## Product Change Notification / GBNG-14UHSW677

CCB 4214.001 Final Notice: Qualification of MMT as a new assembly site for selected MSCC LX3302Axxx and LX34050xxx device families available in 14L TSSOP (4.4mm) package.

# PRE AND POST CHANGE SUMMARY

PCN #: GBNG-14UHSW677

Pre Change

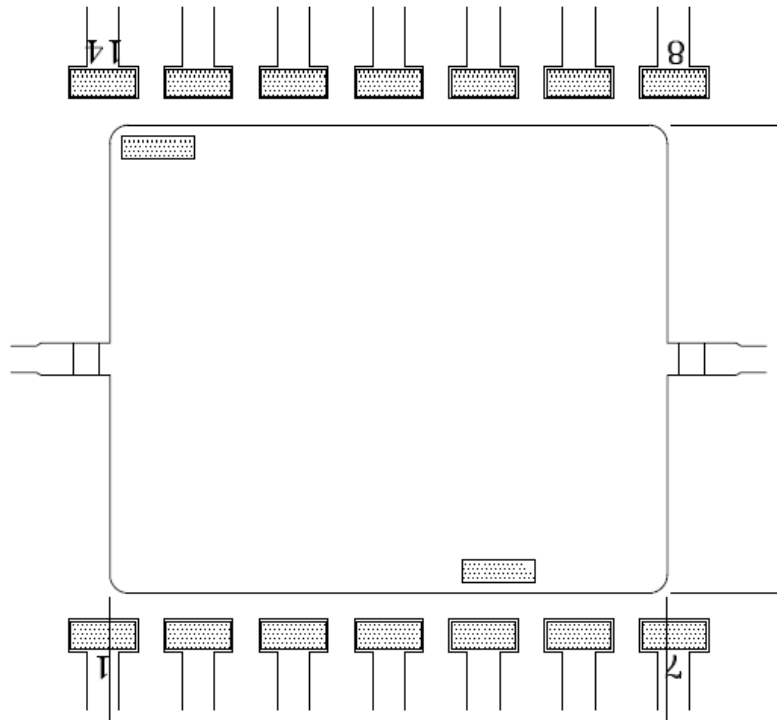
DAP Surface Prep	Copper Spot Ag
Paddle Size	126x150 mils

Post Change

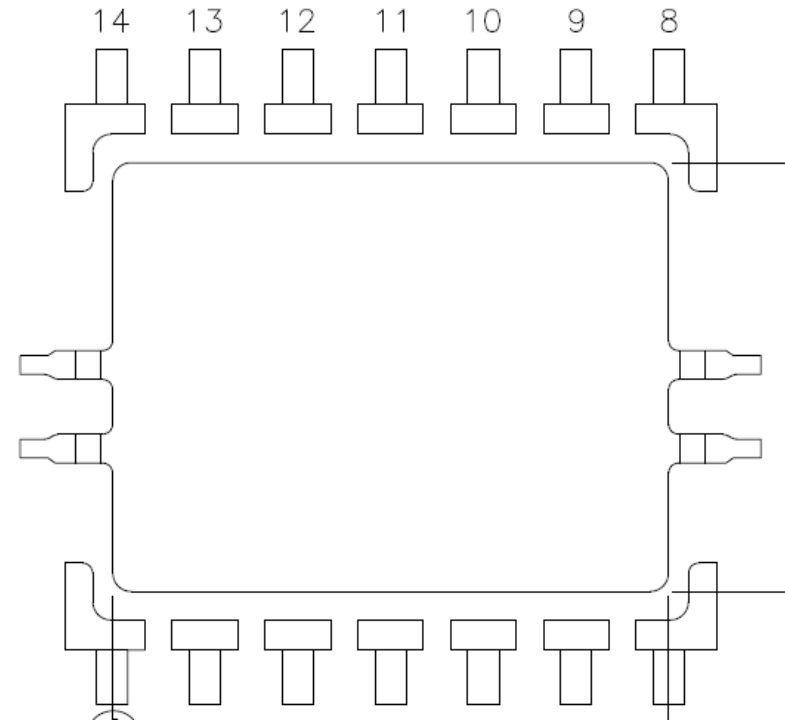
DAP Surface Prep	Bare Cu
Paddle Size	118x153 mils
